BEFORE THE UNITED STATES
ATOMIC ENERGY COMMISSION

In the Matter of)
)
Consolidated Edison Company of)
New York, Inc.)
(Indian Point Station, Unit No. 2))

Docket No. 50-247

Answers of Applicant to Questions Raised
by Atomic Safety and Licensing Board
on January 19, 1971

Figure 6-2

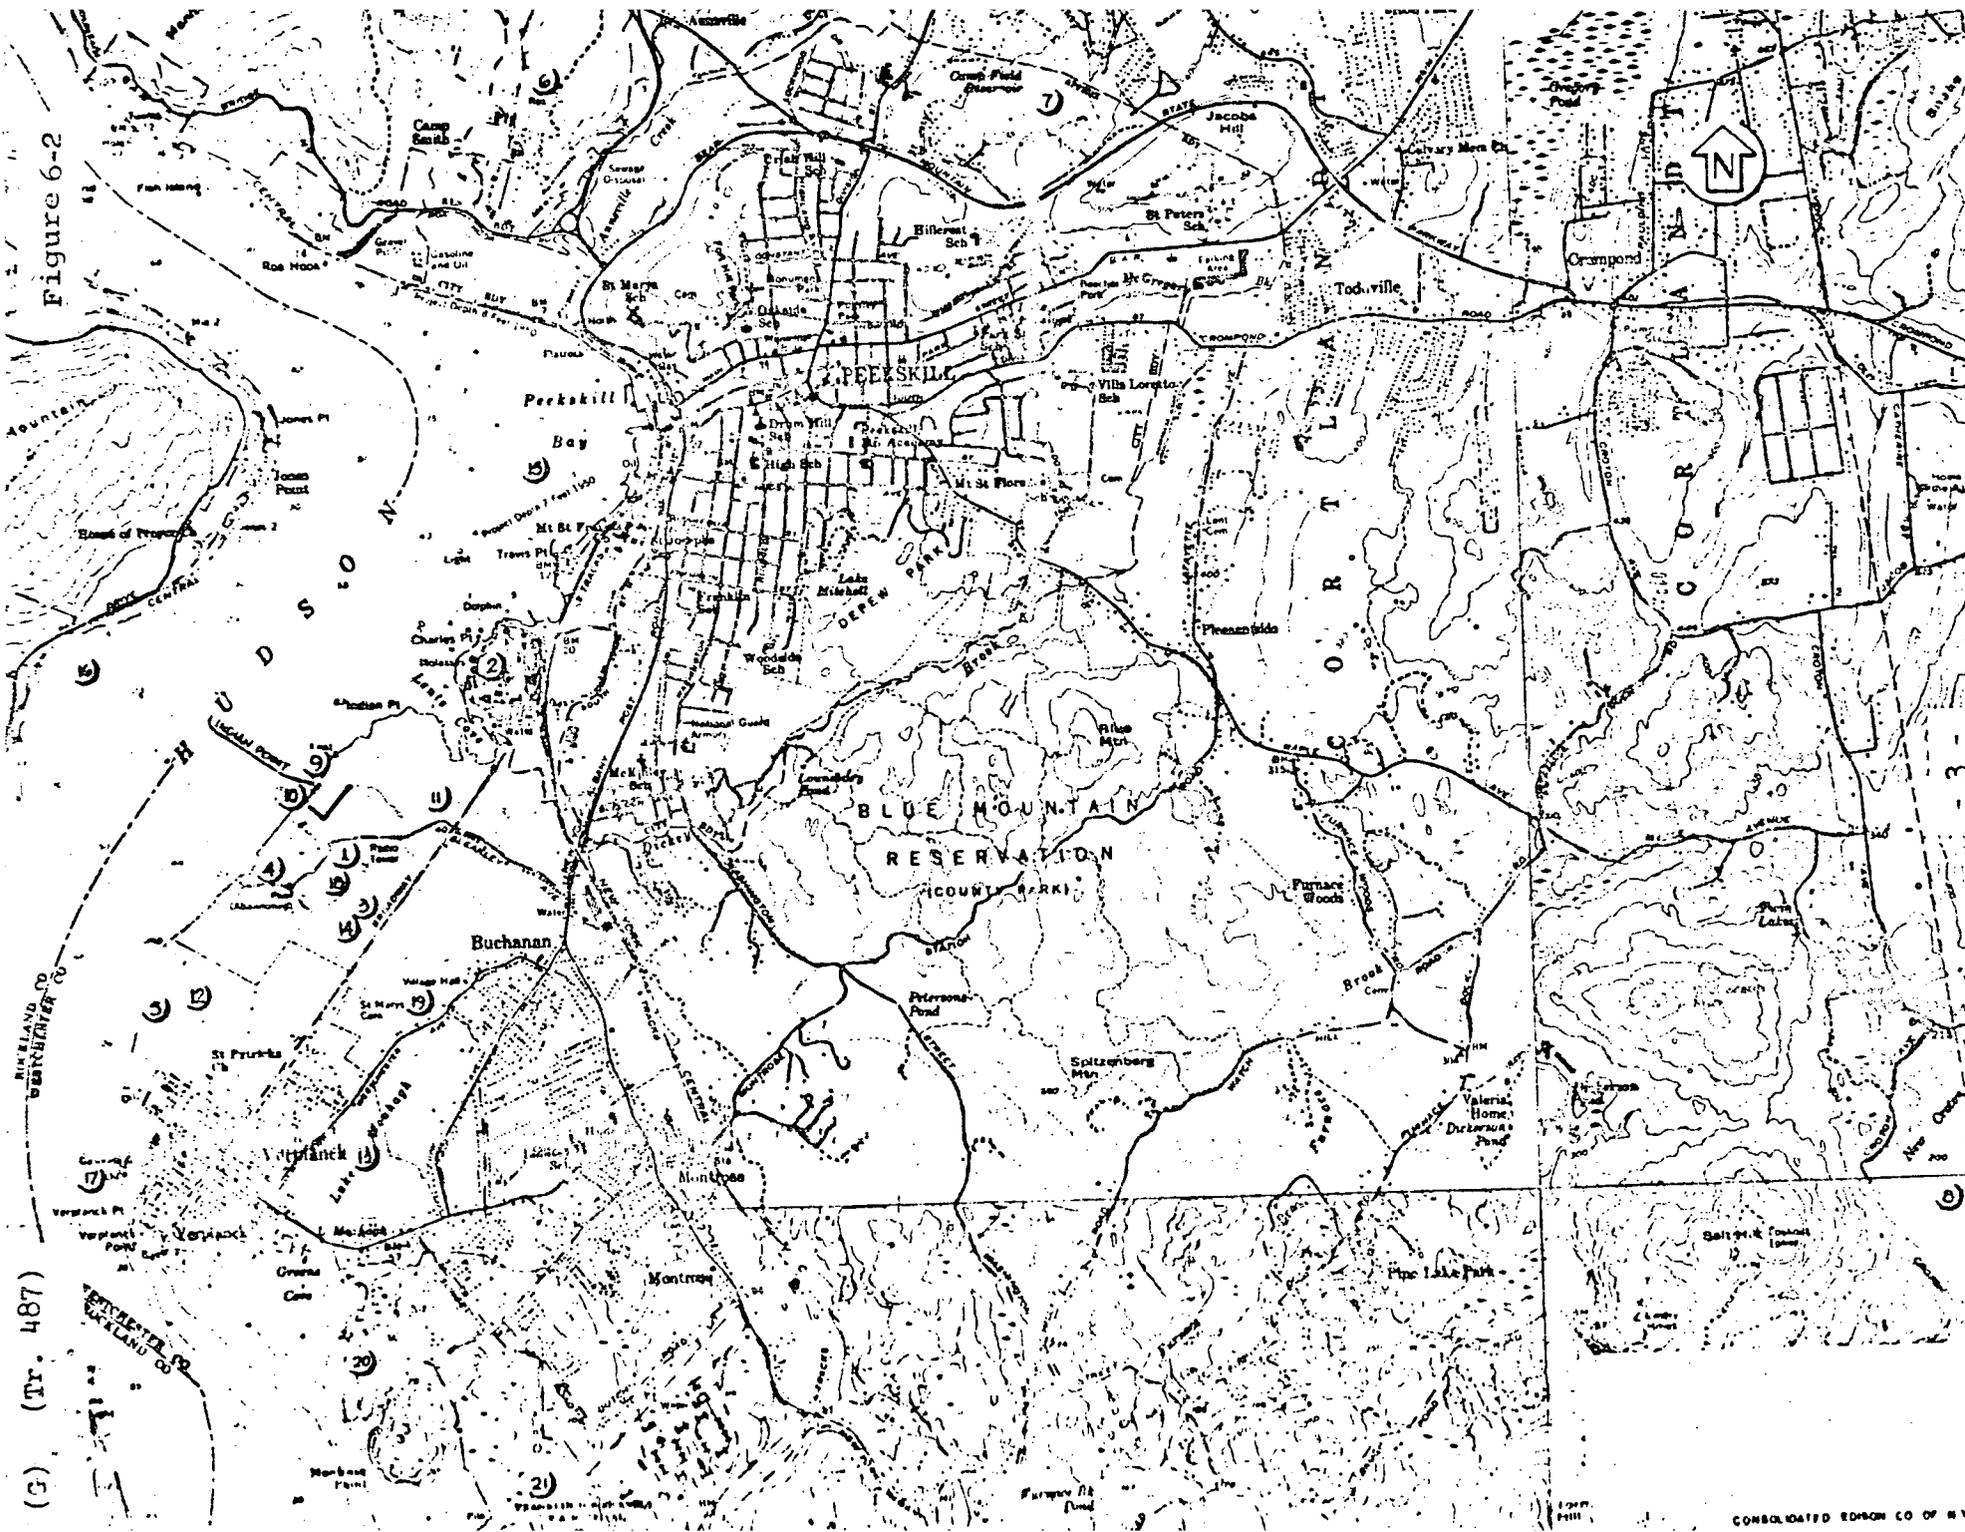
"Also, I would like to find out more about the continuous monitoring system, just where the sensors are located, how much redundancy there is, what kind of alarms they sound and in connection with the discovery of unusual radiation, what provisions are made for warning the public, who makes the decision as to whether the public should be warned.)

There are several types of samples which are taken continuously at various points outside the plant as part of the environmental monitoring program. While these samples are collected continuously they are analyzed on a weekly or monthly basis. These sampling systems have no redundancy, except insofar as there are several sampling points for some types of measurements. There are no alarms associated with any of these samples. These sampling points are described in attached figures 6-1, 6-2 and 6-3.

THERMOLUMINESCENT DOSIMETER LOCATION

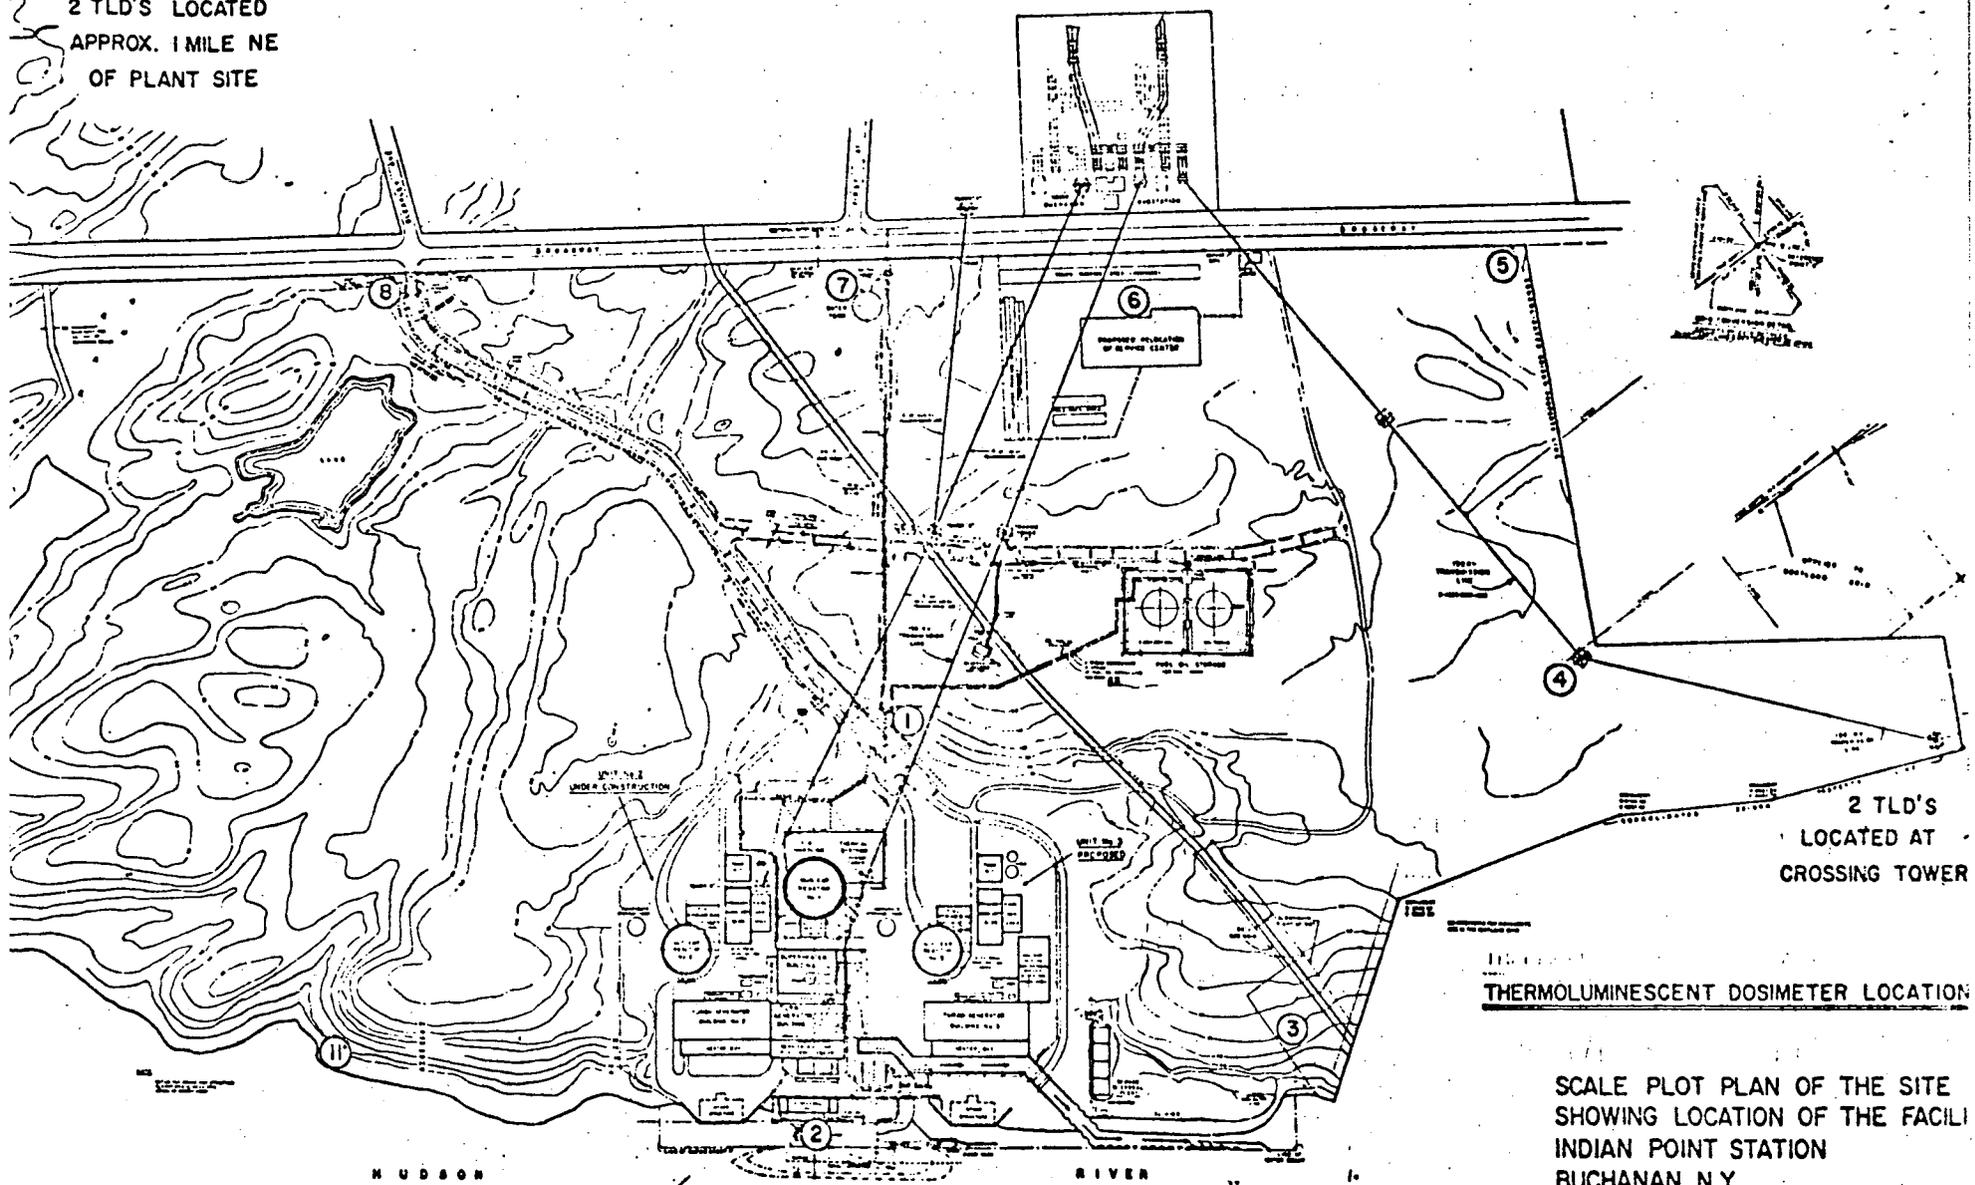
My first question has to do with environmental monitoring, and in the Consolidated Edison Company's report on the environmental impact of Indian Point Station Nuclear Unit No. 2 there is a figure 17 which shows the location of numerous thermal dosimeters. I want to ask about these; what they record, how often they are read, what their full purpose is:"

These dosimeters detect and integrate background gamma and cosmic radiation along with any gamma radiation from the plant. They are read monthly to determine if any change is occurring in the background radiation.

INDIAN POINT UNIT NO. 1
HISTORY OF LIQUID WASTE AND TRITIUM DISCHARGED

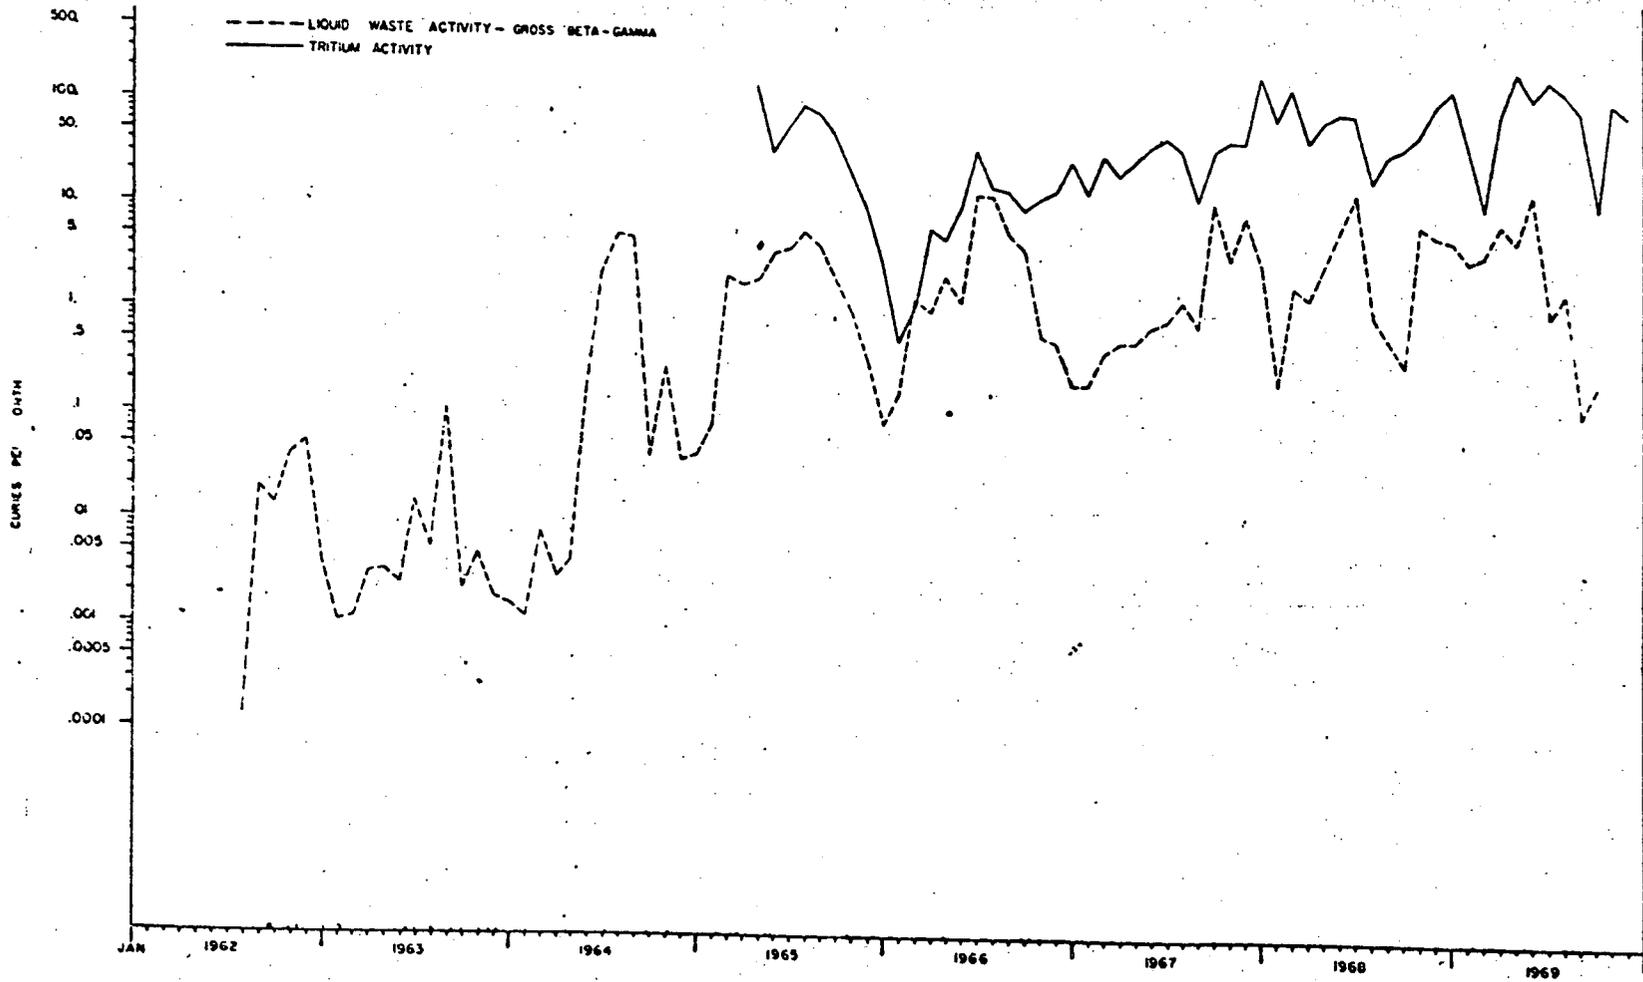
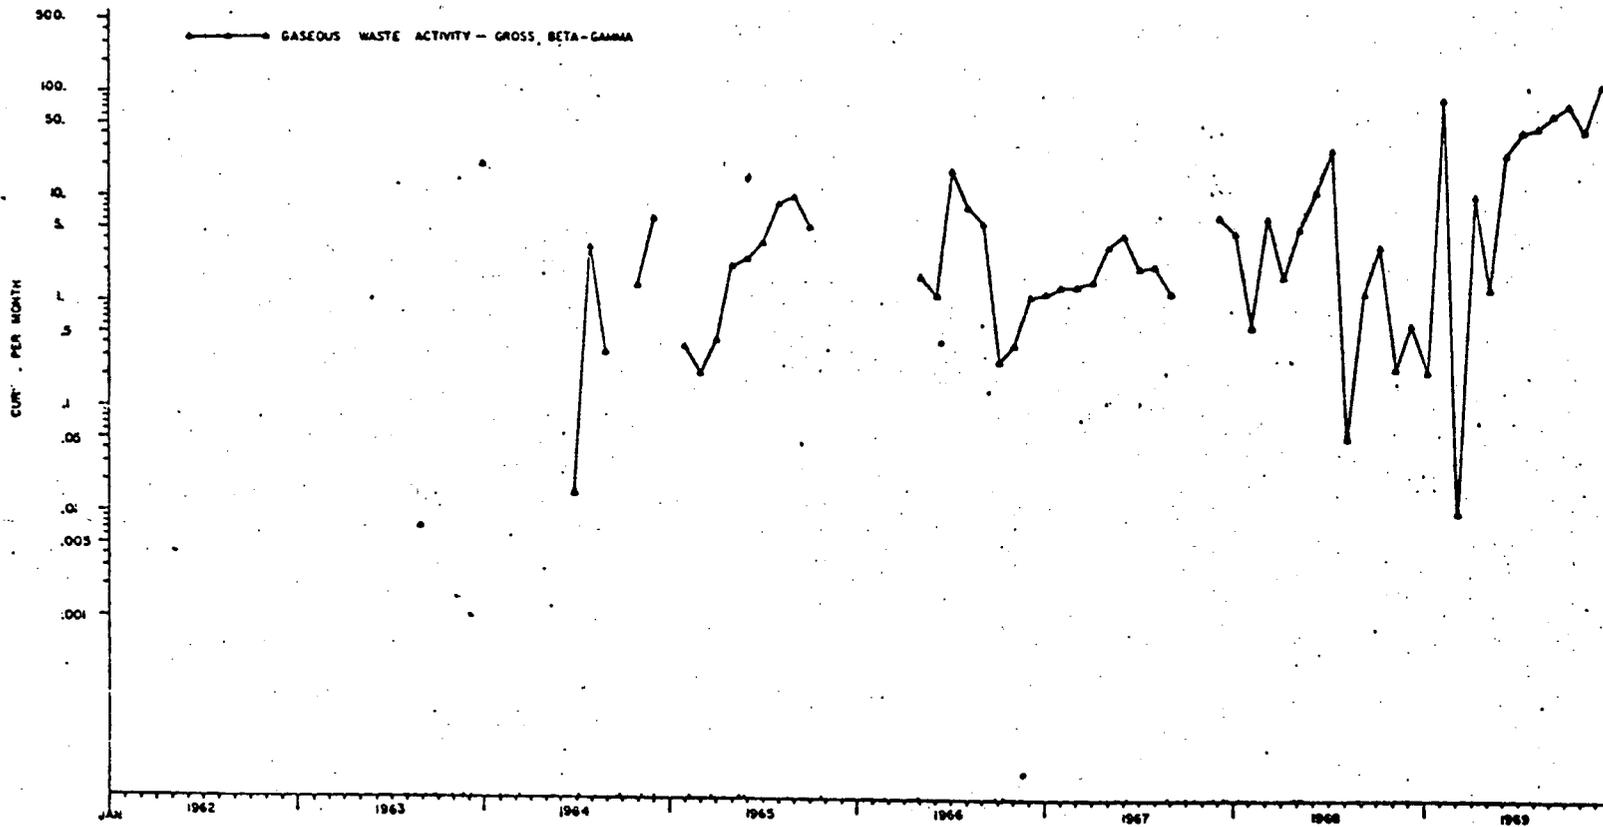
"We would like to have a summary of some of the several monthly reports that have heretofore been submitted with reference to Indian Point No. 1, particularly as to releases of radioactive liquid and gases and compare those with the readings by the New York environmental surveillance groups and if there are any other surveillance groups...."

Two graphs are attached summarizing the liquid and gaseous releases from Indian Point Unit No. 1.
